RECEIPT DATE: 3/23/17 **ONSITE SEWAGE DISPOSAL SYSTEM** P 560580-1

RE: Vista Ridge Lot 13
2046 Drovers Lane
Cooksville, MD 21723
"BAT Plan & Site Plan"

DATE	10/20/16	PROJECT No.	1635
ATTENTION	Robert Freeman		
RE:	Vista Ridge Lot 13		
	2046 Drovers Lane		
	Revised BAT Plan

TITLE: SEPTIC PERMIT SITE PLAN

**TRENCH/DRAINFIELD DATA**

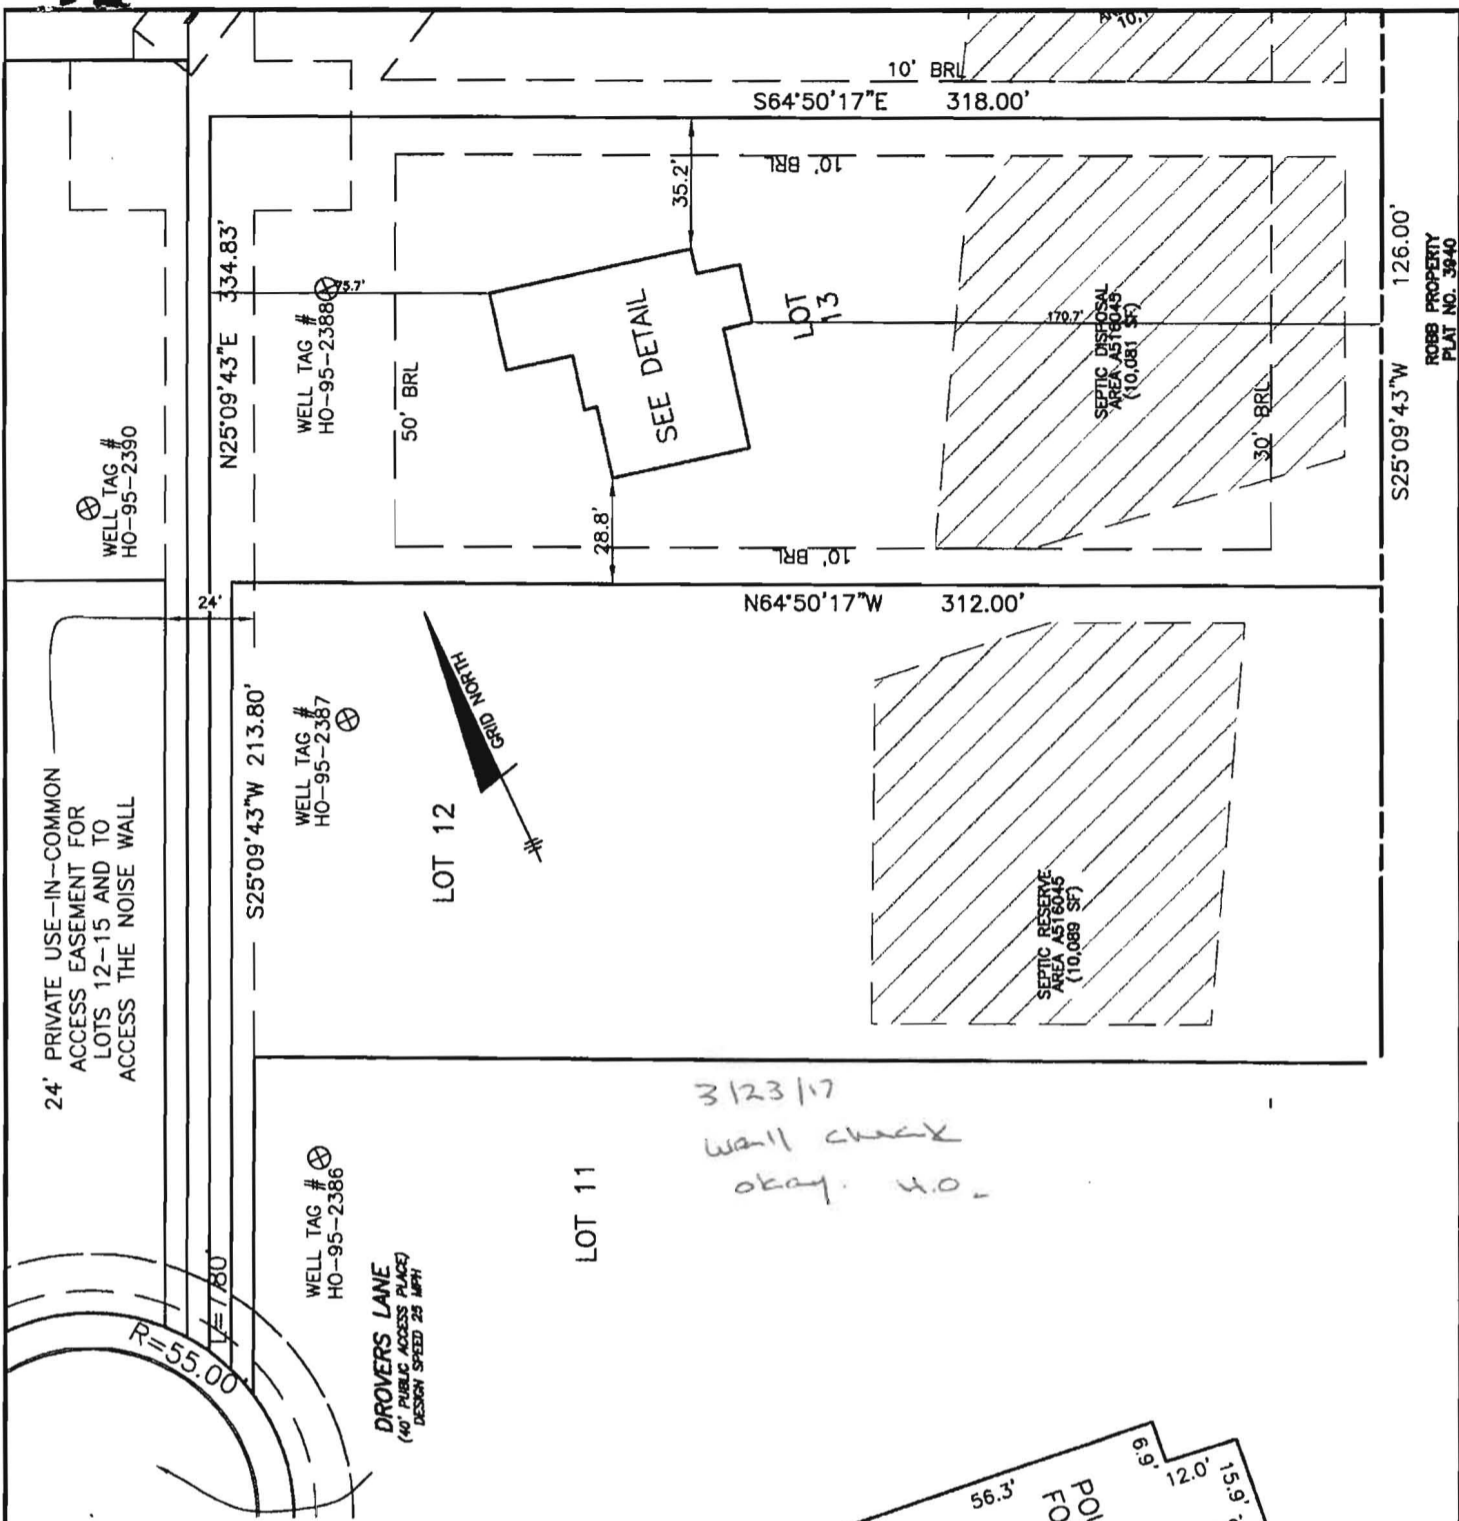
3/30/17 Met Fogle's on site for layout. All SDA stakes present. Shot contour + laid out 5x42' trenches on contour. (SC)

INSTALLATION: 4/3/17 Tank + D-box set, pipe laid from house to D-box. Need house connection. Fogle's could not make 3' inlet, okay to do 4' inlet and 8' bottom. (SC)

4/4/17 T1 finished + left open at ends, Fogle's adding stone to T3. 3' wide, 4' to stone. No laser used while digging trenches - they don't have access to one for today. I told them they need one on site. (SC)

4/5/17 Trenches complete - left open at ends. 3' wide, 4' to stone. Levelled speed levelers in D-box. Need house connection. (SC)

5/26/17 House connection complete. Settling around tank and at end of T3 - notified builder + final grading with fix next week. (SC)

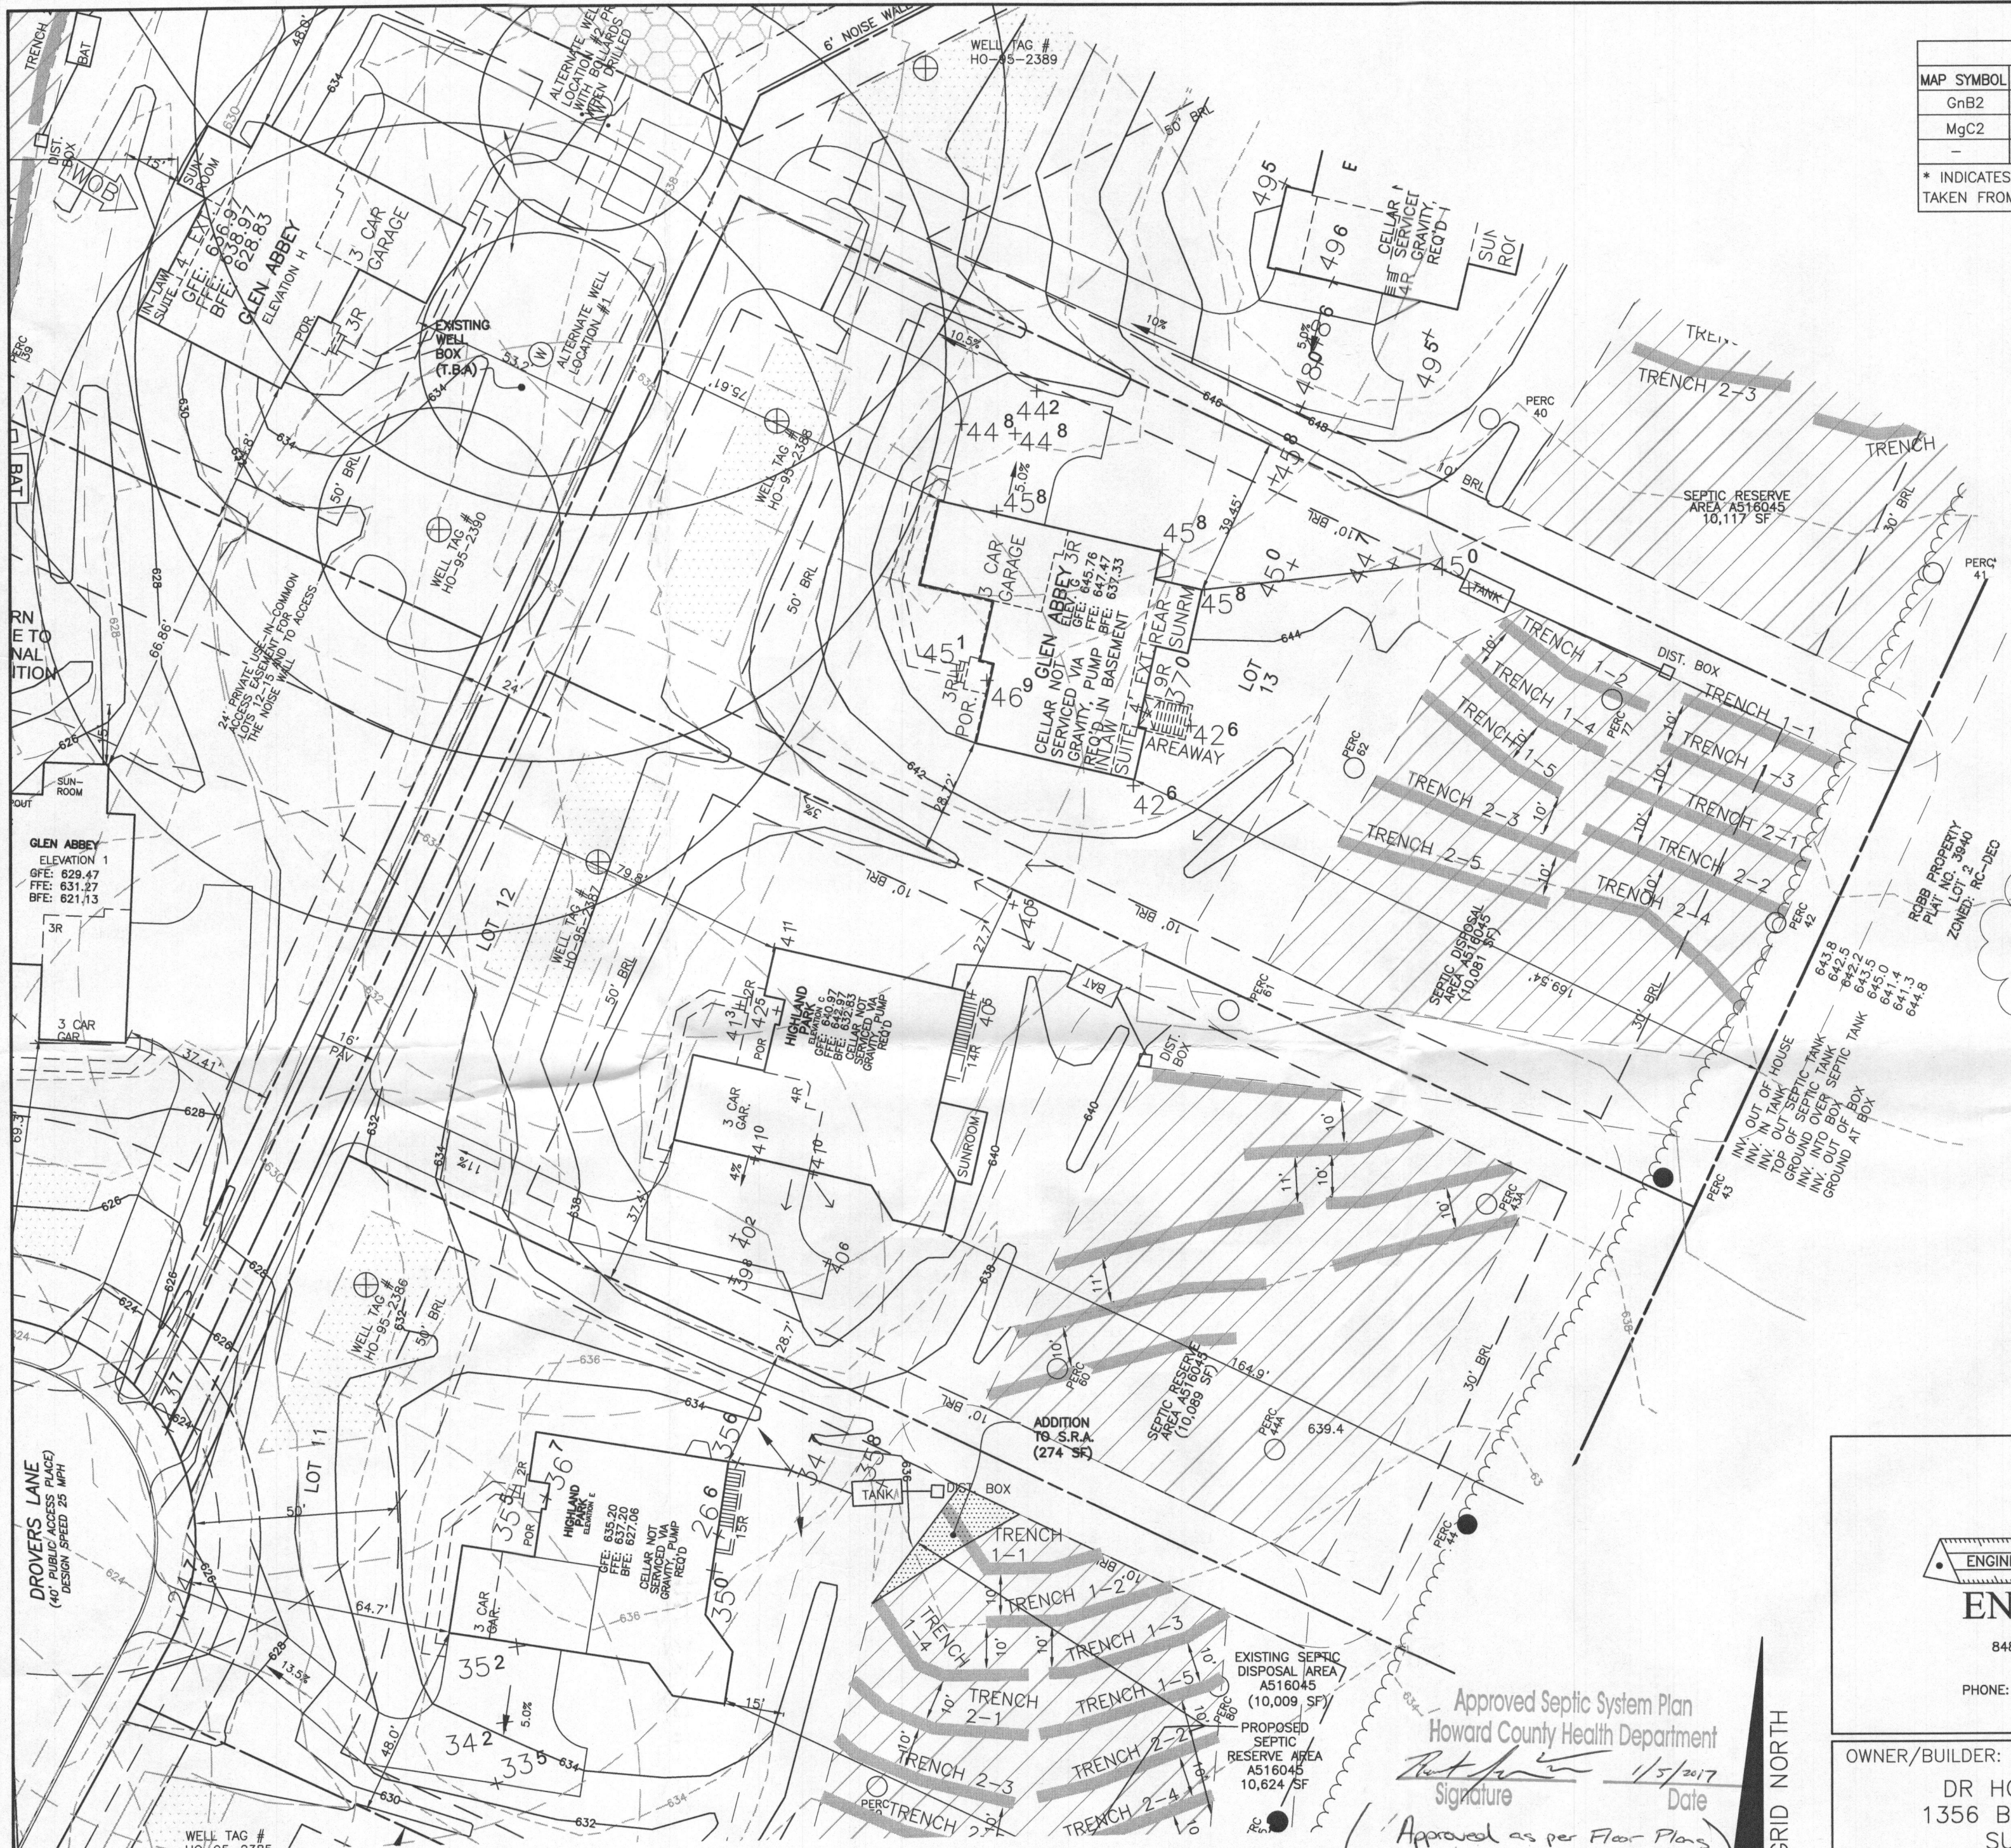
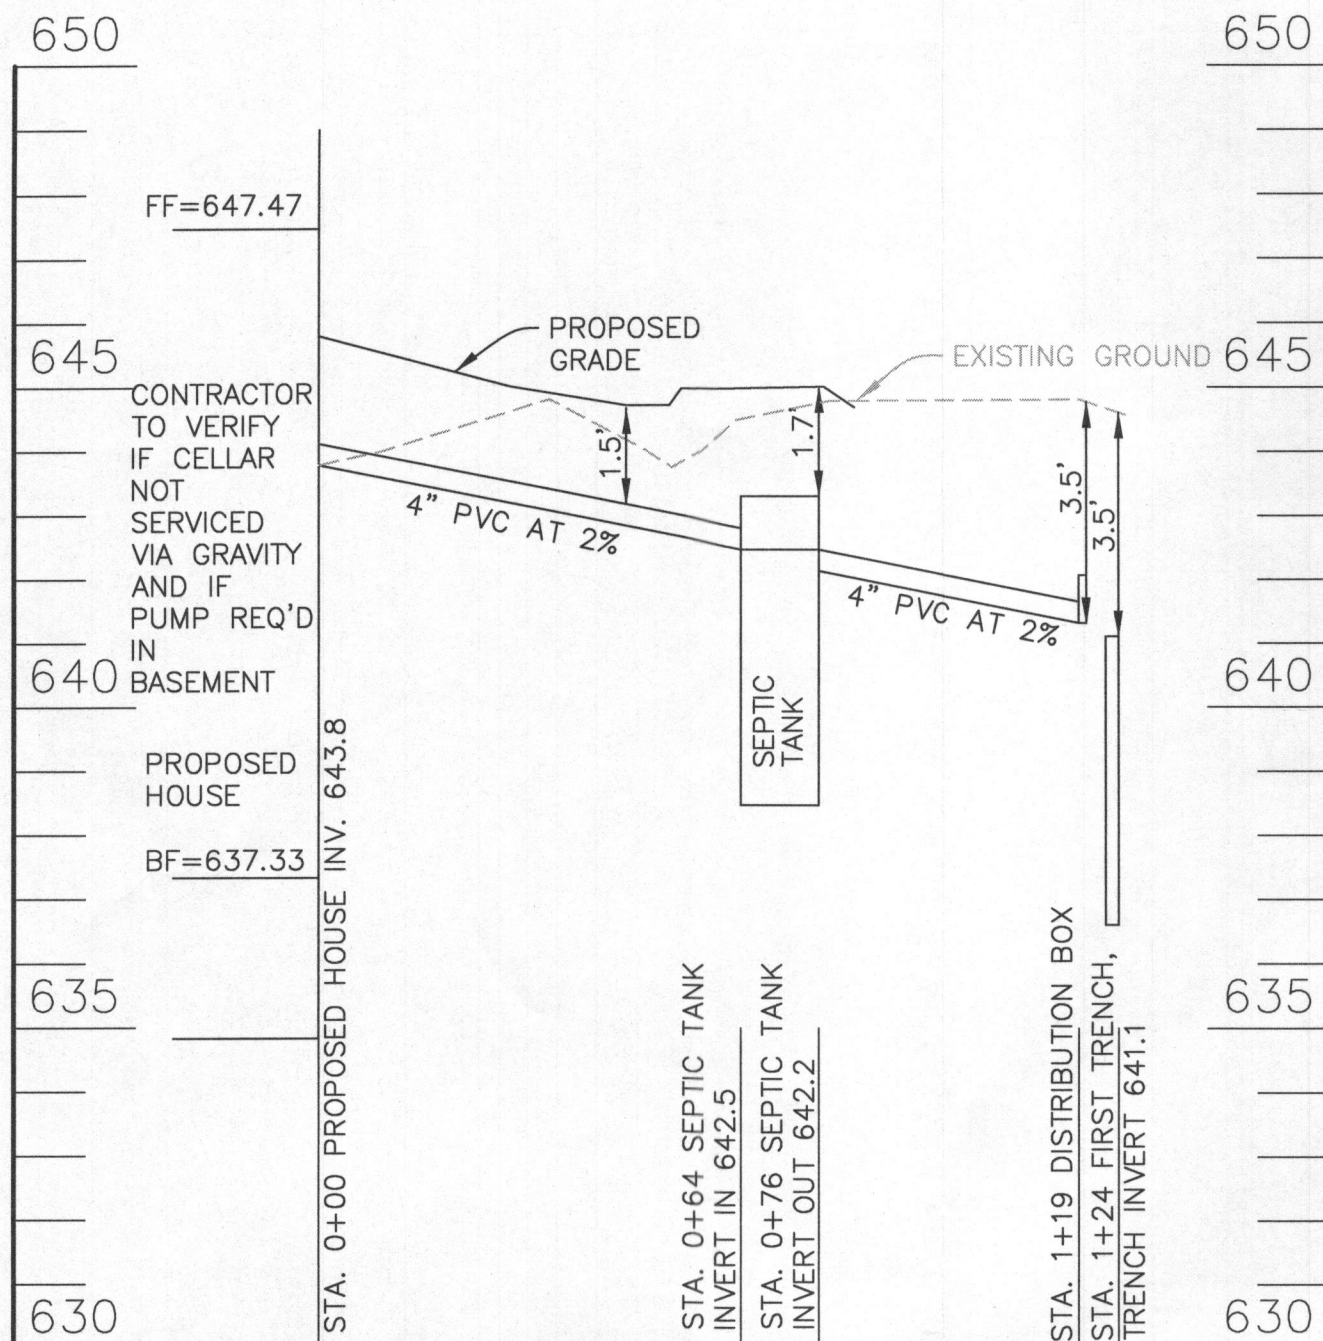
After talking to fogels we want to do standard systems on lots 11,13,17.

*Revised to a Regular Septic Tank*
